DOCKETED	
Docket Number:	23-AFC-01
Project Title:	Morton Bay Geothermal Project (MBGP)
TN #:	257274
Document Title:	Morton Bay Geothermal LLC Responses the The LV Equity Technical Advisory Group Comments on the ICAPCD PDOC
Description:	N/A
Filer:	Lindsey Xayachack
Organization:	Jacobs
Submitter Role:	Applicant Consultant
Submission Date:	6/21/2024 12:54:08 PM
Docketed Date:	6/21/2024

# RE: <u>Selected Responses to The LV Equity Technical Advisory Group Comments on Preliminary</u> Determination of Compliance for the Morton Bay Geothermal Plant

Figure I.4-1 Comparison of Wind Roses Morton Bay Geothermal Project Imperial County, California

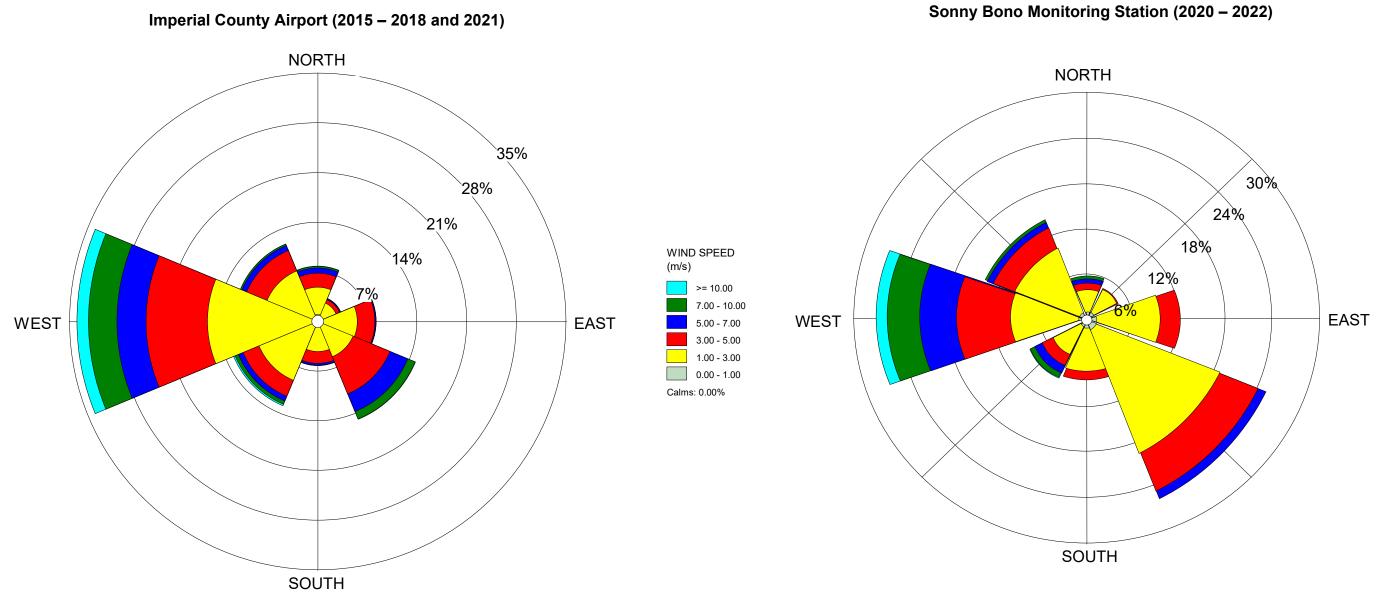
- 4. Meteorological data should be representative of the proposed project site, for example using the Sonny Bono monitoring station and/or Comite Civico del Valle's IVAN air monitoring

network. The current analysis relies on distant data from an Airport that is many miles away from the project site, as California Unions for Reliable Energy (CURE) recently pointed out in relation to the proposed Elmore North project.<sup>2</sup>

**Response:** The dispersion model utilized the most representative, accurate, and reliable meteorological data available, consistent with EPA Guidelines. In particular, the Applicant reviewed the meteorological data collected at the Sonny Bono monitoring station and found that only two years of recent data (2020 and 2022) from that station meet the EPA requirements of 90 percent minimum completeness before substitution on a quarterly basis.<sup>10</sup> To ensure the worst-case meteorological conditions are adequately represented in the model results, the EPA requires the use of five years of adequately representative National Weather Service (NWS) meteorological data, at least one year of site-specific data, or at least three years of prognostic meteorological data.<sup>11</sup>

In addition, the Sonny Bono monitoring station is not an Automated Surface Observing Systems (ASOS) station, unlike the Imperial County Airport NWS station. ASOS stations are those monitoring stations which collect sub-hourly 1 to 5-minute wind speed and wind direction readings. To reduce the number of calms and missing winds in the surface data, archived 1-minute winds for the ASOS stations can be used to calculate hourly average wind speeds and wind directions, which are used to supplement the standard archive of hourly observed winds processed in the AERMOD Meteorological Preprocessor (AERMET).

Lastly, although the Imperial County Airport is located over 28 miles from the project site, there are no significant geographic features between the two locations, and both are located south/southeast of the Salton Sea. The lack of significant geographic features between the two locations is itself an indicator of representativeness of the Imperial County Airport meteorological data,<sup>12</sup> but also leads to the expectation that wind speeds and wind directions in the project vicinity are similar to those incurred at the Imperial County Airport. This expected similarity is verified by comparing the wind rose for the Imperial County Airport (for years 2015 to 2018 and 2021) to the wind rose for the Sonny Bono monitoring station (for years 2020 to 2022). As shown in Figure I.4-1, attached hereto, both wind roses share the predominant wind directions from the west and southeast.

Based on the above, the meteorological data collected at the Sonny Bono monitoring station is not more suitable for modeling as the data does not meet the minimum requirements for completeness and would not be any more representative of the project site than the Imperial County Airport data based on a comparison of wind roses. Furthermore, as an ASOS station, the Imperial County Airport NWS station may provide fewer missing hours of wind speeds and wind directions. For these reasons, the Applicant supports the continued use of the Imperial County Airport NWS station meteorological data, as previously approved both by the ICAPCD and CEC.
